**TOWN OF LEESBURG
TOWN COUNCIL PUBLIC HEARING**

Subject: Rezoning Application TLZM-2013-0006, Crescent Parke

**TOWN OF LEESBURG
PLANNING COMMISSION PUBLIC HEARING**

Figure 2, Concept Plan

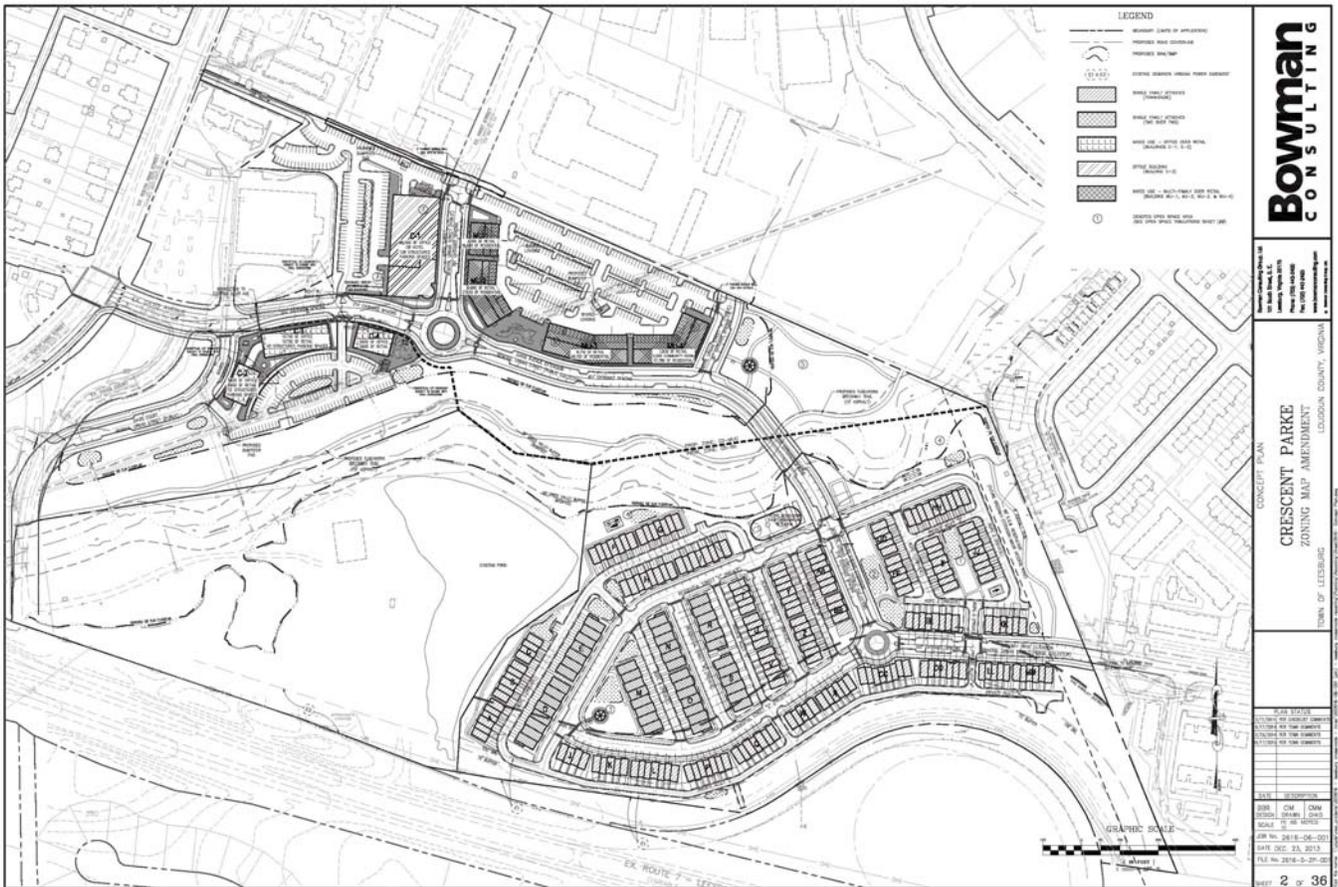
The land bay south of the Tuscarora Creek is proposed as CD-RH. Contrary to the Crescent District Master Plan and the intent of the current zoning district this land

Figure 6, Fourth Submission

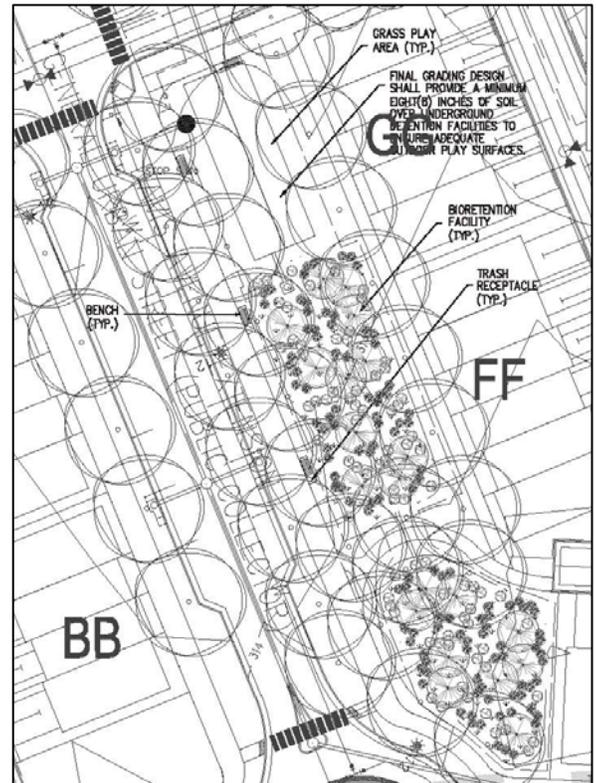
Staff notes the changes made with this revised submission continue to erode active recreation areas. To cite an example, the mews or pocket parks located in close proximity to residential units have been diminished with the expansion of bio retention facilities. See figures 5 and 6.
